DECISION OF THE PLANNING COMMISSION

**CLASS 3 DESIGN REVIEW / CLASS 3 SITE PLAN REVIEW / CLASS 2
DRIVEWAY APPROACH PERMIT / TREE REGULATION VARIANCE CASE NO.
DR-SPR-DAP-TRV18-07**

SUMMARY: Proposed development of a new 111-unit apartment complex.

LOCATION: 1881 Wiltsey Road SE, Salem, OR 97306

SDR3

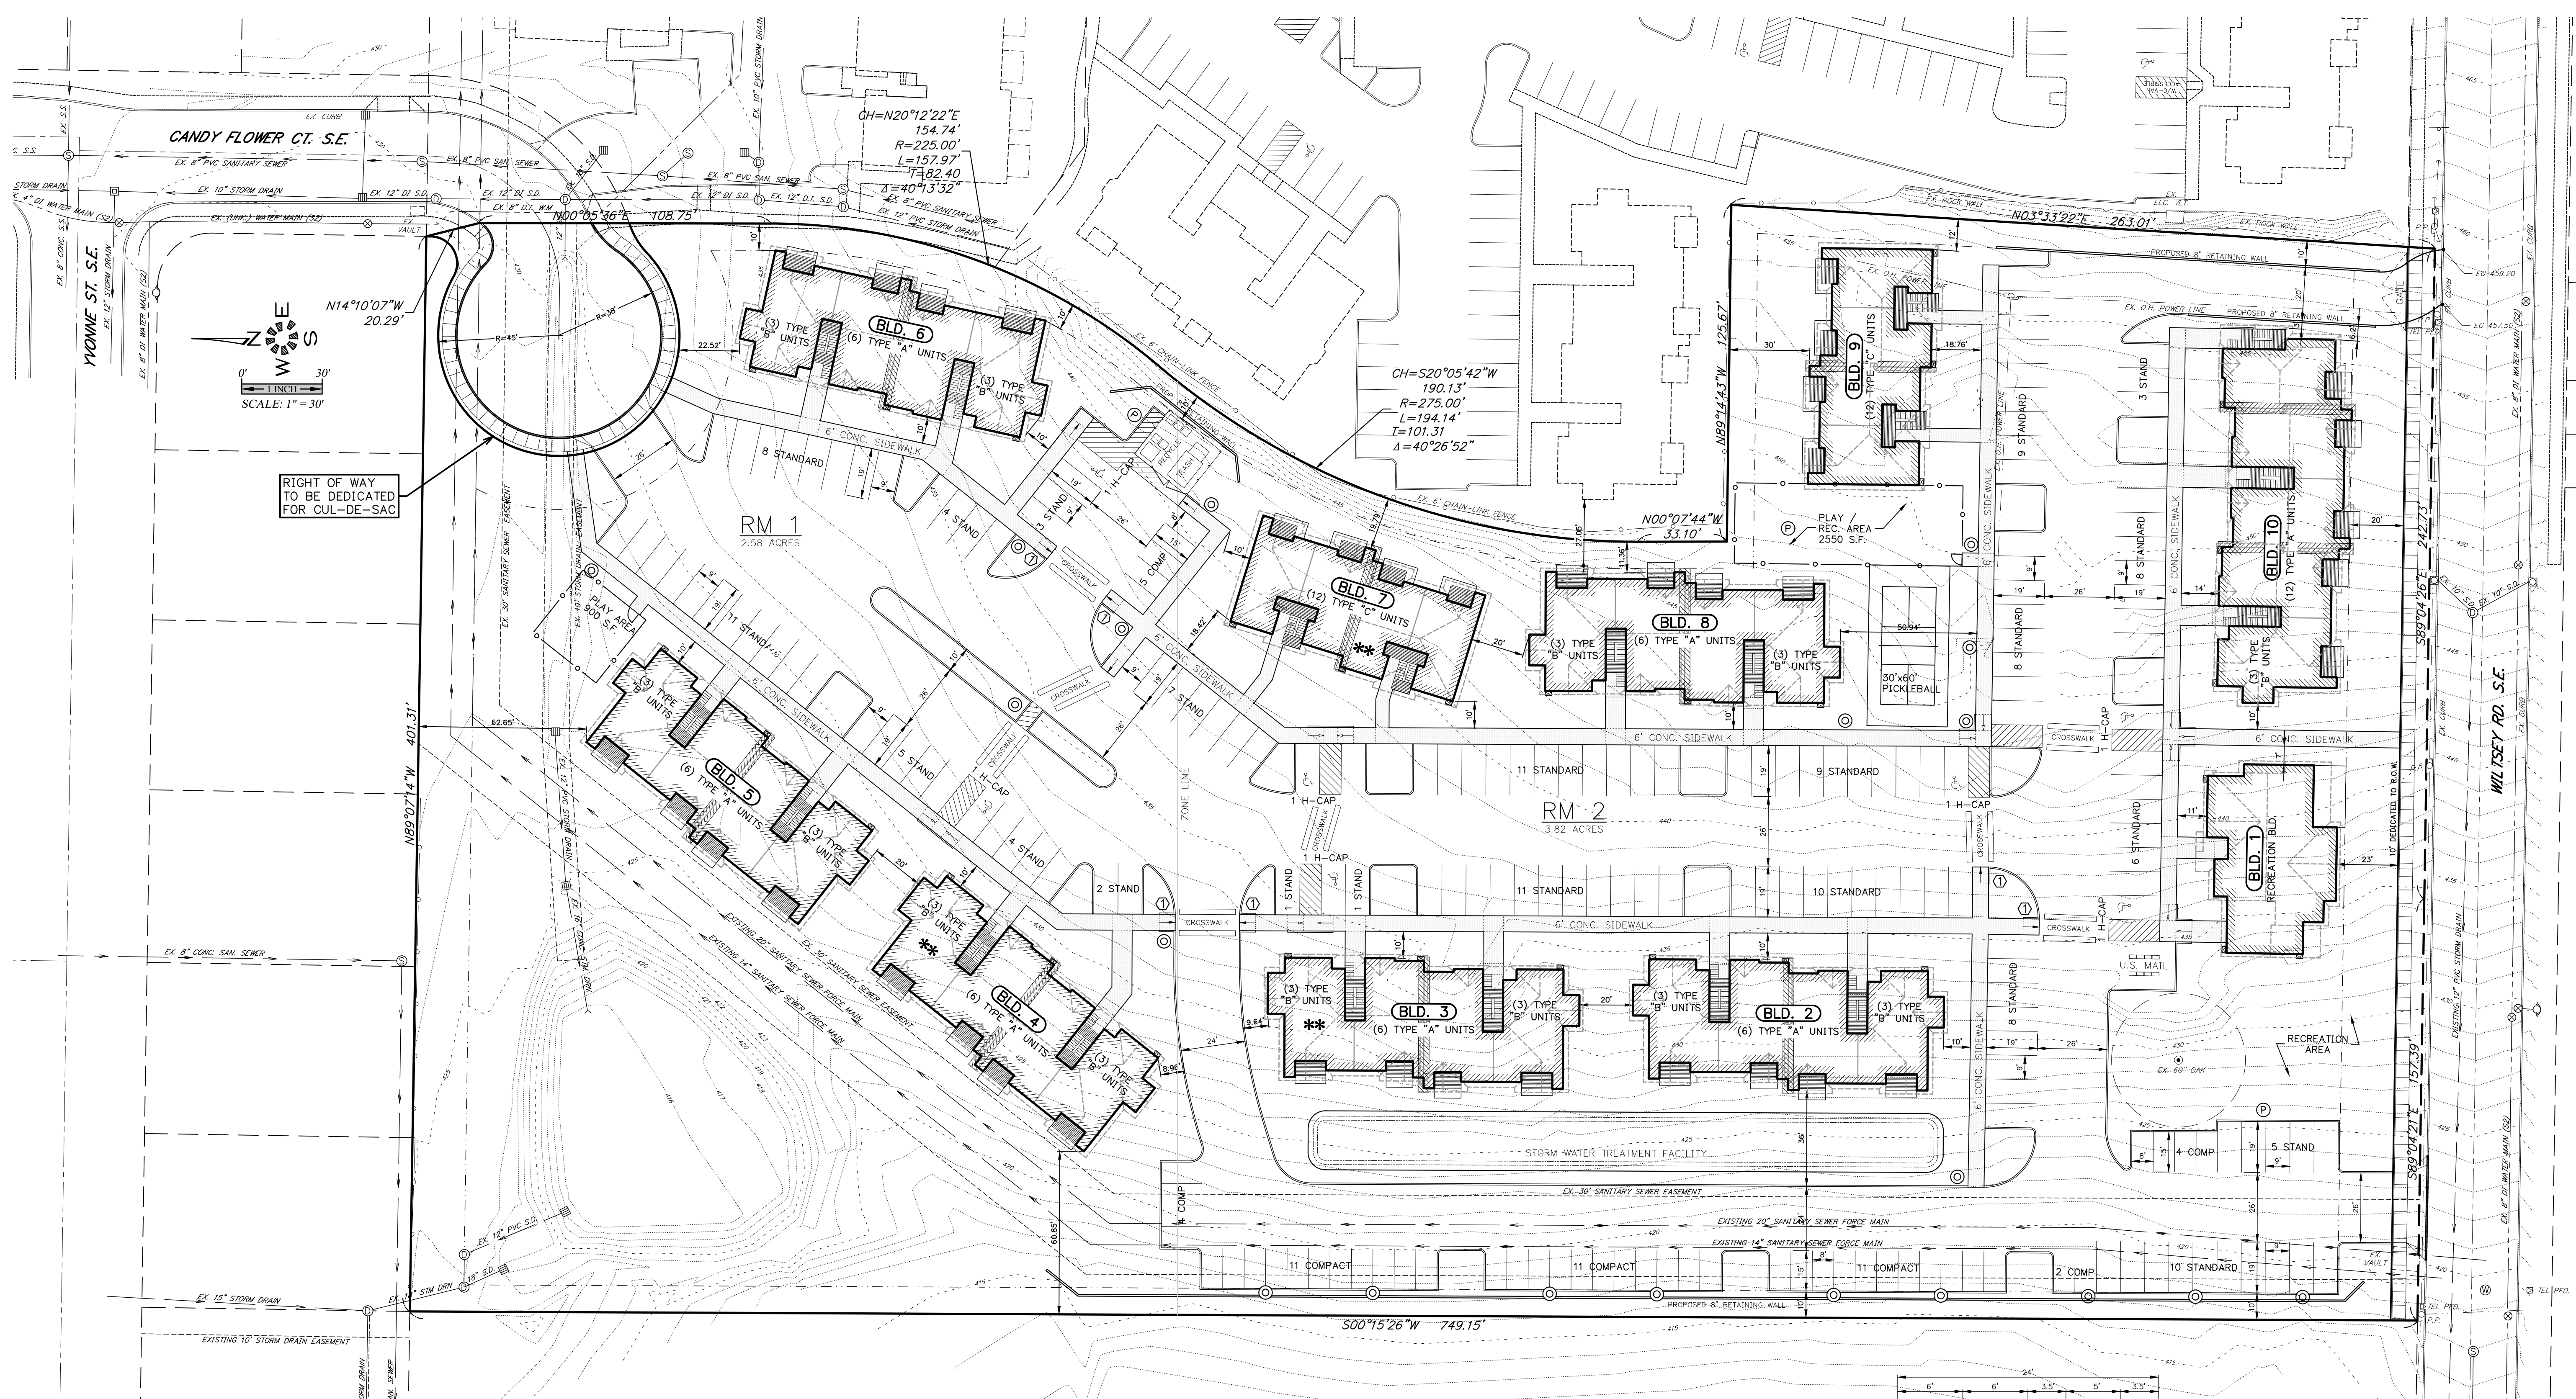
- Condition 3:** Prior to building permit issuance, the site plan shall be modified to include a minimum of two off-street loading spaces for the proposed use, meeting applicable location and dimension requirements of SRC Chapter 806.

Proposed building 10 is on the setback line adjacent to Wiltsey Road SE and is approximately 135 feet in width. In addition, proposed building 1 is approximately 70 feet in length, but is located off the 20 foot setback. The applicant is requesting a reduction to the buildable width standard to provide an open space area that preserves an existing significant tree near the southwest portion of the property.

The site plan proposes the dedication of new right-of-way for Candy Flower Court SE near the northeast portion of the property. Proposed building 6 is placed near the 20 foot setback line for Candy Flower Court SE, however a significant portion of the buildable width adjacent to Candy Flower Court SE is occupied by utility easements for storm drainage and sanitary sewer. The applicant is requesting a reduction to the buildable width standard because of physical limitations of the easements.

Finding: The proposed site plan indicates that the enclosure walls will be cmu block. A bumper curb 12 inches inside the perimeter of the outside walls of the enclosure is required, however the curb is not indicated on the proposed plans.

Finding: The applicant's statement and proposed site plan does not address the minimum off-street loading requirement for the development.

Condition 3: Prior to building permit issuance, the site plan shall be modified to include a minimum of two off-street loading spaces for the proposed use, meeting applicable location and dimension requirements of SRC Chapter 806.

L1.1

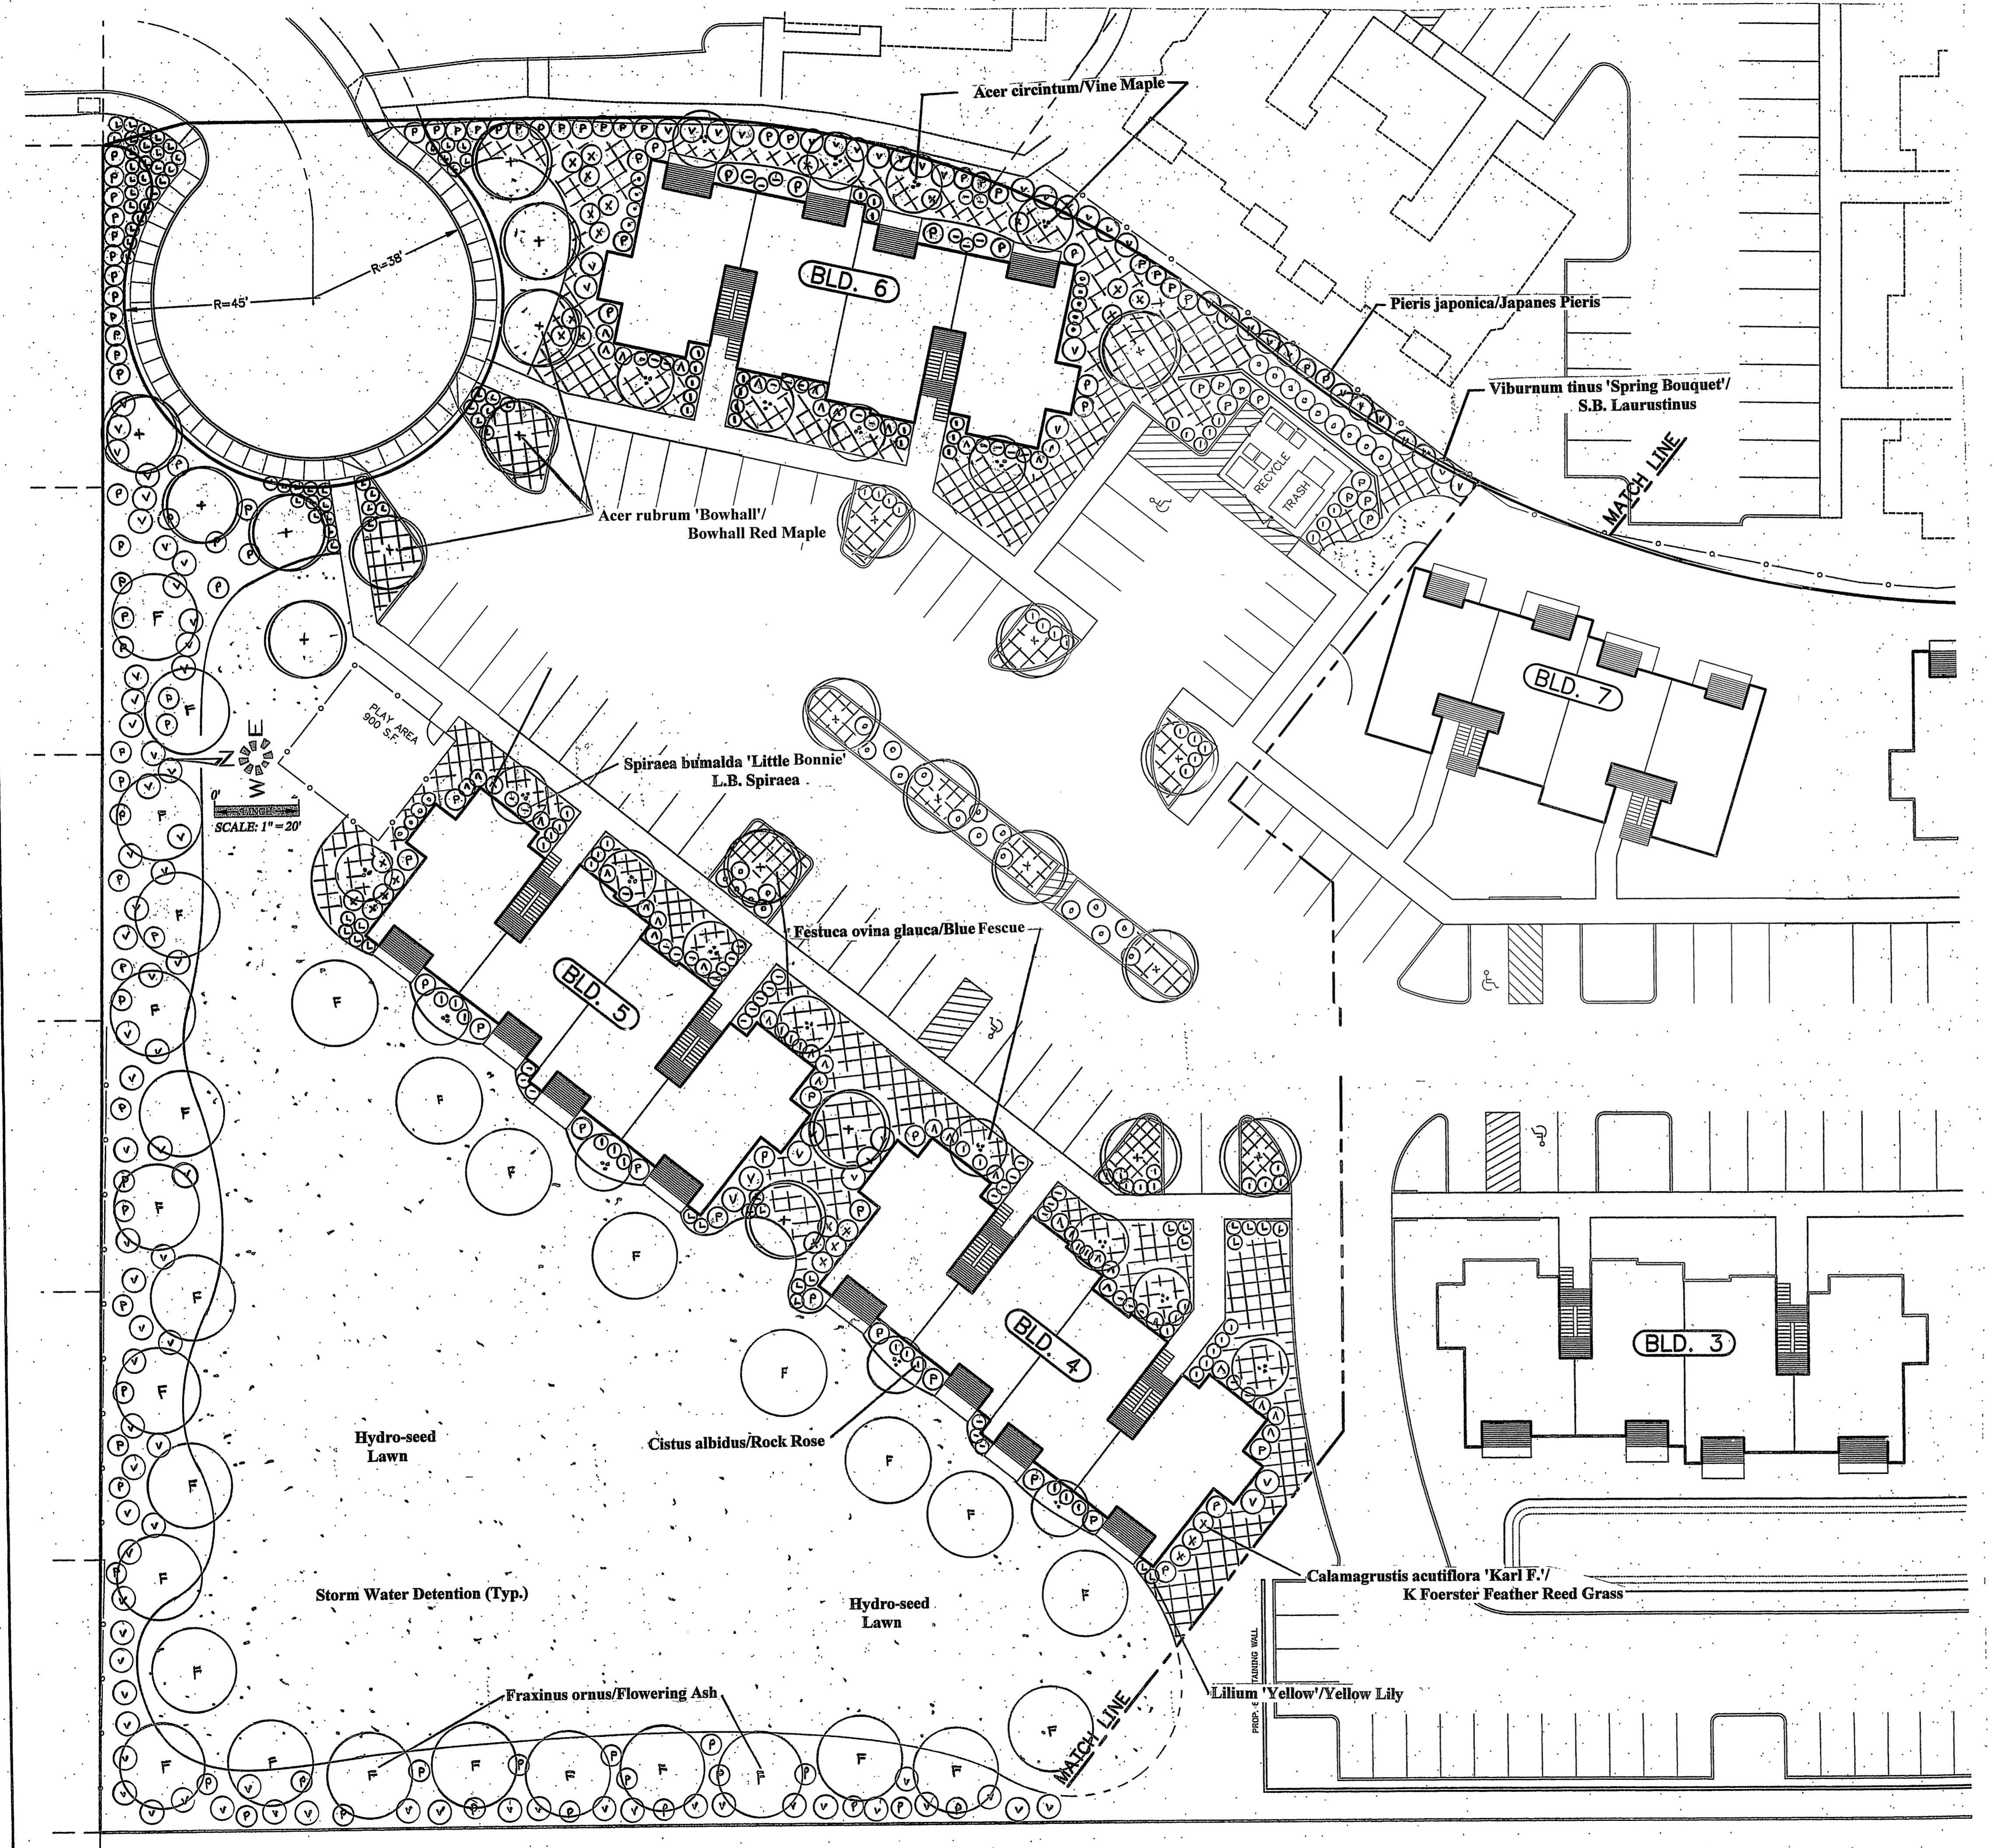
- Condition 4:** Per SRC 807.030(d)(2), when more than 75 percent of the existing trees are proposed for removal, a minimum of two replacement trees shall be incorporated into the landscape plan and planted, in addition to the landscaping required under this chapter. For the removal of 79 trees in excess of 75 percent, a total of 158 replacement trees shall be provided.

- Condition 12:** A minimum of eight Oregon White Oaks (*Quercus garryana*), with a minimum caliper of 2", shall be incorporated into the landscape design and replanted for the proposed development.
